City of Miami Beach

Last Completed Item Reviews Across All Submittals

Permit: RV2114494

Description of Work: DRIVEWAY REVISION

SHEET:
3 OF 3

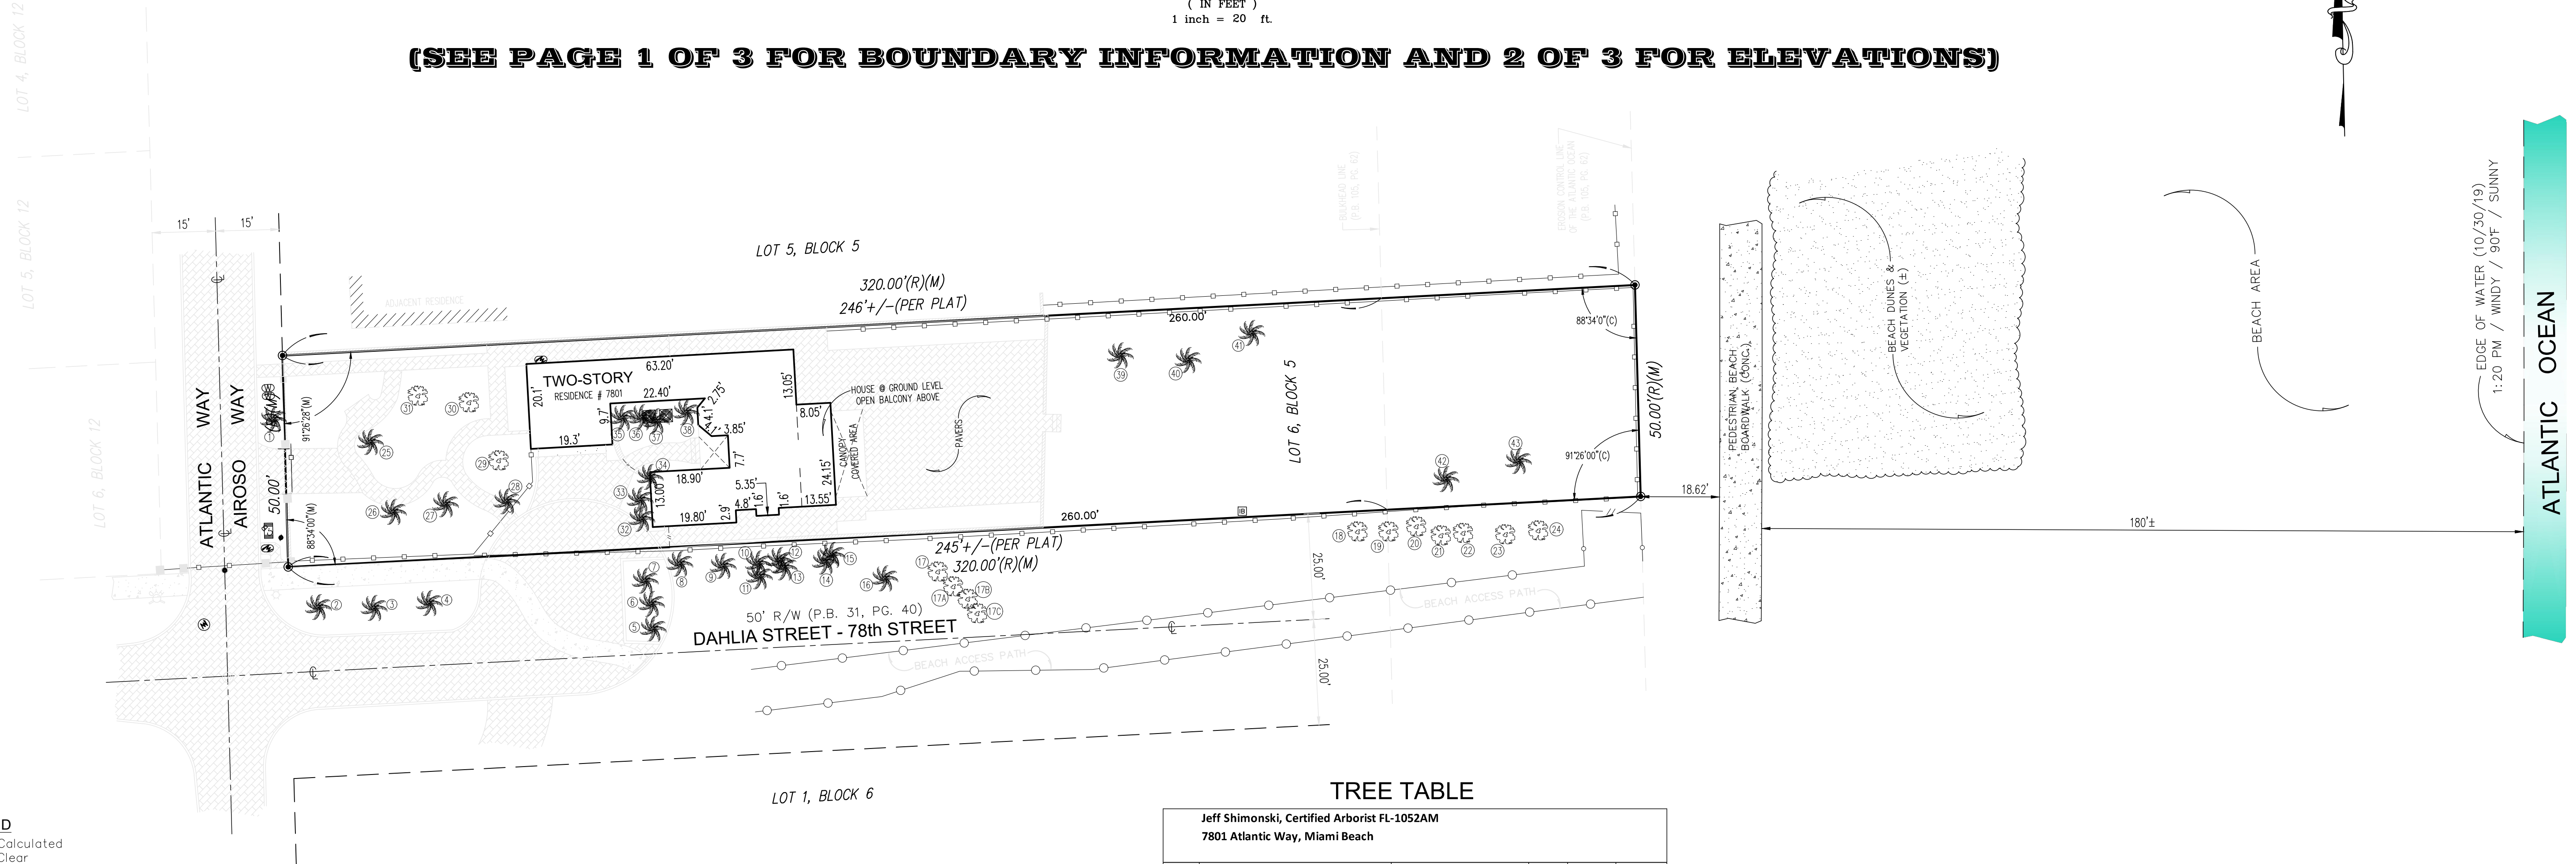
Provide a Tree Survey prepared by a Professional Land Surveyor listing the common names, sizes, and locations of existing trees and palms with a DBH of 6" or greater. If removal of trees is required, please provide a Tree Disposition Plan. Removal of any non-invasive trees with a 6" DBH or greater from private property would require a Tree Removal Permit from CMB Urban Forestry. Removal of any non-invasive trees with a 3" DBH or greater from public property would also require a Tree Removal Permit from CMB Urban Forestry

RESPONSE: REFER TO FILE NAME: JN 19-5113 B PAGE 3 OF 3 (1).PDF FOR TREE SURVEY INCLUDING THE LOCATION FOR ALL EXISITNG TREES, PALMS AS WELL AS DBH INFORMATION AND CANOPY. TREE REMOVAL IS NOT REQUIRED AS NO TREES ARE AFFECTED. THIS REVISION PERTAINS TO THE EXISTING PATHWAY CONNECTING DRIVEWAYS. INCLUDED TREE PROTECTION PLAN WHICH INCLUDED IN MASTER SET FOR REFERENCED.

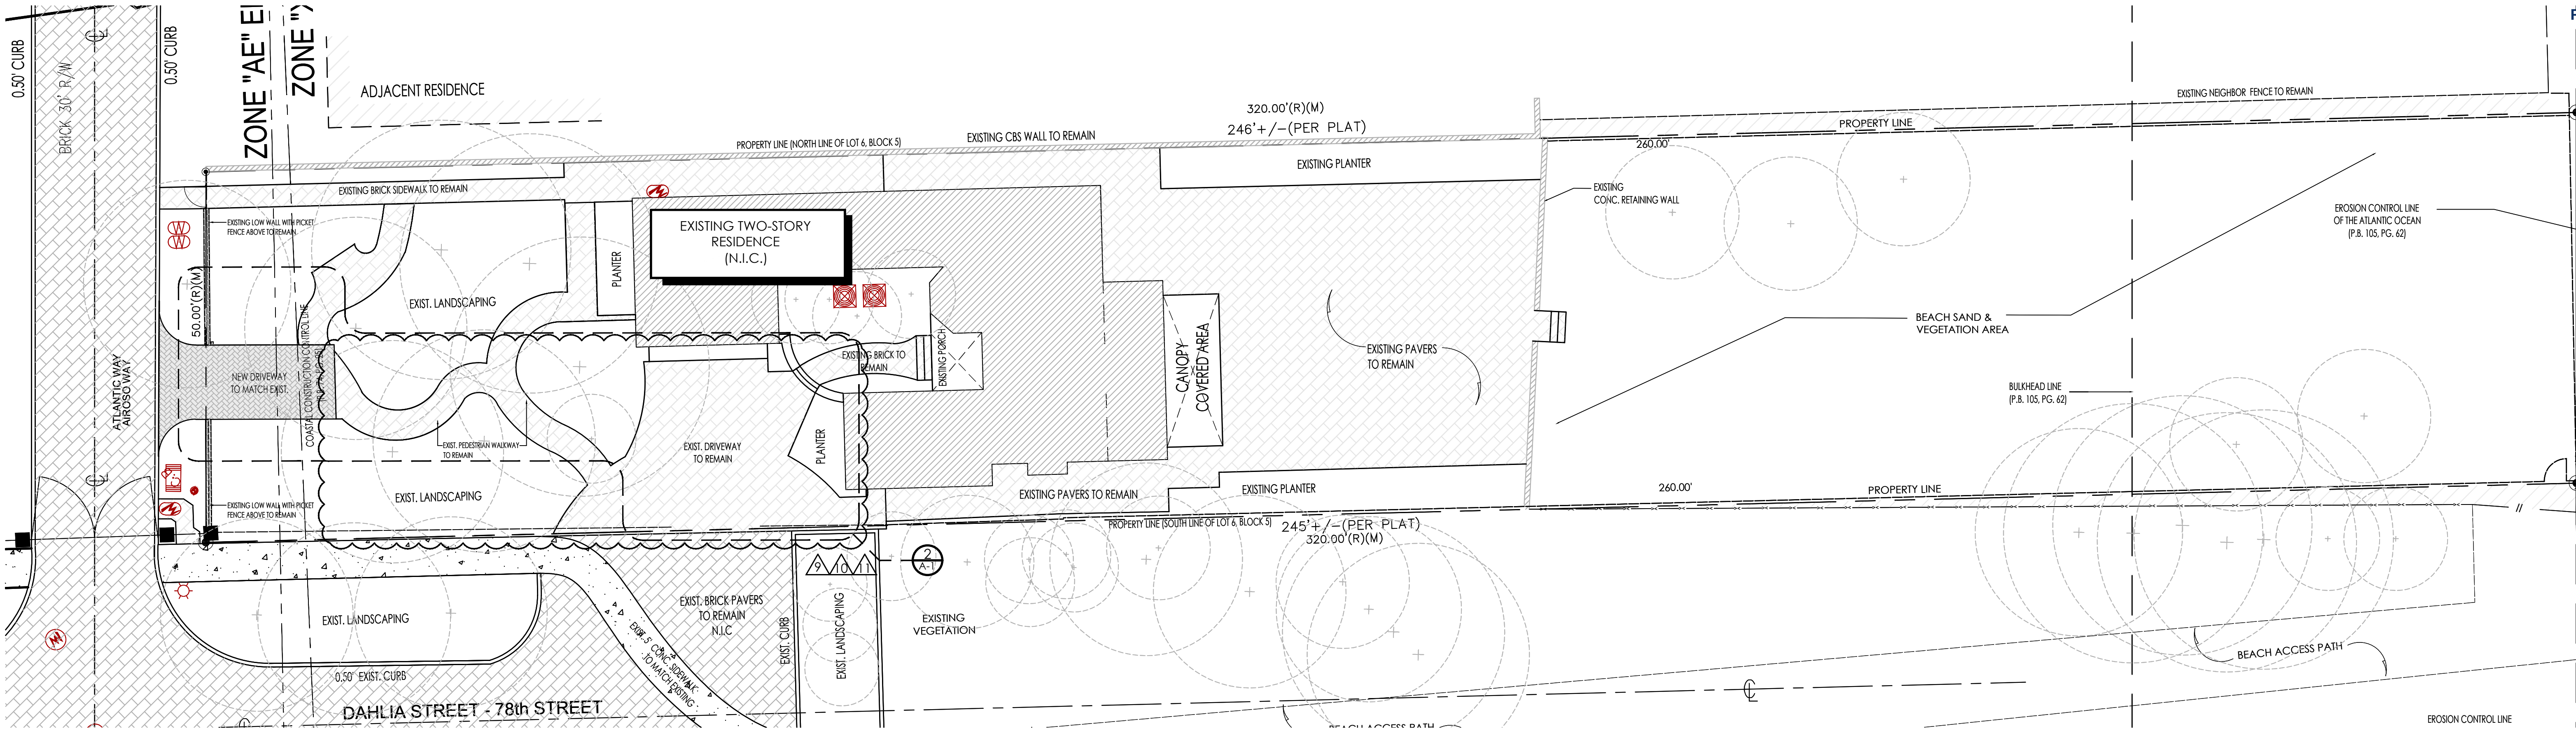
Proposed work could come in direct conflict with existing trees/palms. Please include a tree survey drawn to scale identifying the species and listing the height, spread and DBH of all existing trees/palms. The tree survey shall be prepared by and bear the seal of a professional land surveyor, licensed in the State of Florida. In addition, a tree disposition and site plan drawn to scale identifying and listing all existing trees/palms and specifying the condition of each tree and whether such trees/palms are to remain, to be removed or to be relocated shall be provided. This plan shall also illustrate the location of all existing structures and/or all proposed new construction, as applicable, the location of any overhead and/or underground utilities, the new locations of existing trees/palms to be relocated on site, and all areas affected by construction-related activities, such as access routes to the property, and staging area. The plan shall be prepared by and bear the seal of a landscape architect currently licensed to practice in the State of Florida. If you have any questions or concerns please contact us at urbanforestry@miamibeachfl.gov Please provide us with your process number and contact information and we will get back to you within 48hrs.

RESPONSE: REFER TO FILE NAME: JN 19-5113 B PAGE 3 OF 3 (1).PDF FOR TREE SURVEY INCLUDING THE LOCATION FOR ALL EXISTING TREES, PALMS AS WELL AS DBH INFORMATION AND CANOPY. TREE REMOVAL IS NOT REQUIRED AS NO TREES ARE AFFECTED. THIS REVISION PERTAINS TO THE EXISTING PATHWAY CONNECTING DRIVEWAYS. INCLUDED TREE PROTECTION PLAN WHICH INCLUDED IN MASTER SET FOR REFERENCED
